In response to your application dated December 10, 1979, supplemented by letters dated February 6 and March 24, 1980, the Commission has issued the enclosed Amendment No. 42 to Facility Operating License No. DPR-25 for Dresden Nuclear Power Station Unit 3.

DRESDEN NUCLEAR POWER STATION UNIT NO. 3

Amendment No. 42  
License No. DPR-25

ATTACHMENT TO LICENSE AMENDMENT NO. 42

Figure 3.5-1 MAXIMUM AVERAGE PLANAR LINEAR HEAT GENERATION RATE (Kw/ft) vs. PLANAR AVERAGE EXPOSURE (Sheet 5 of 5)

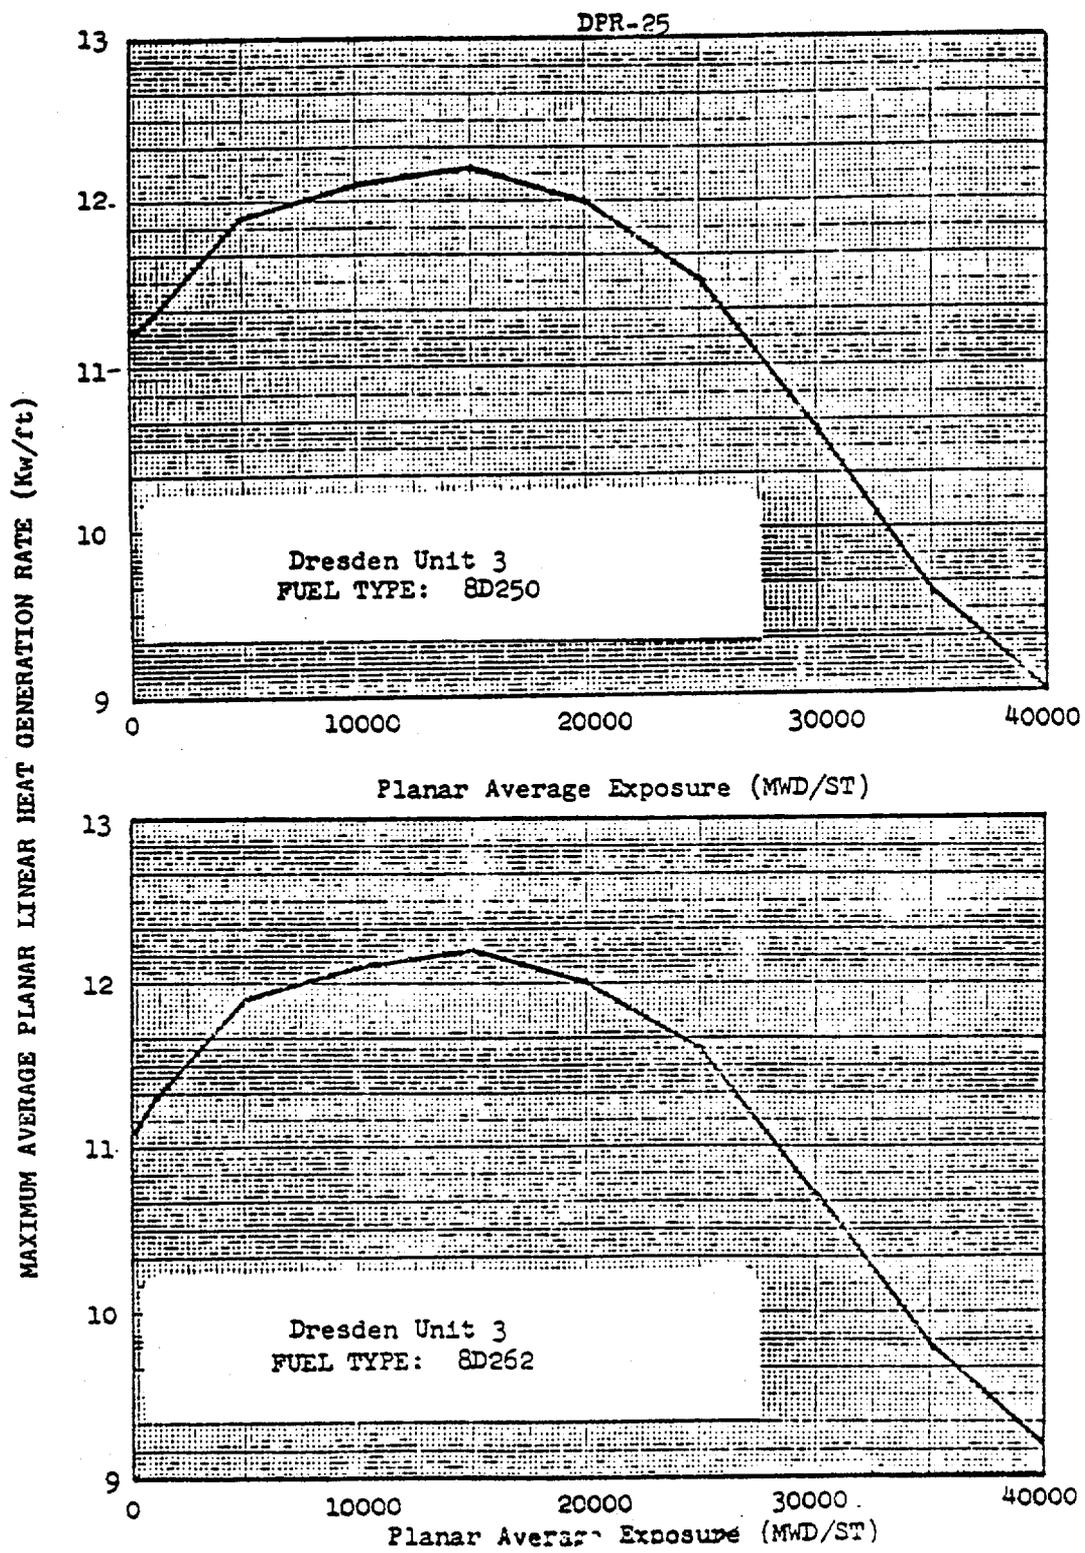
### Maximum Average Planar Linear Heat Generation Rate (MAPLHGR)

The LHGR power spiking penalty for 8x8 fuel has been incorporated in the safety analyses by the reduction of the LHGR limit by an equivalent amount. This change has been generically accepted by our Reference 5 letter.

The maximum average planar ICHG shown in Figure 3.5.1 are based on calculations employing the models described in Reference (1). Power operation with ICHGs at or below those shown in Fig. 3.5.1 assures that the peak cladding temperature following a postulated loss-of-coolant accident will not exceed the 2200°F limit. Those values represent limits for operation to ensure conformance with ICFR50 and Appendix K only if they are more limiting than other design parameters.
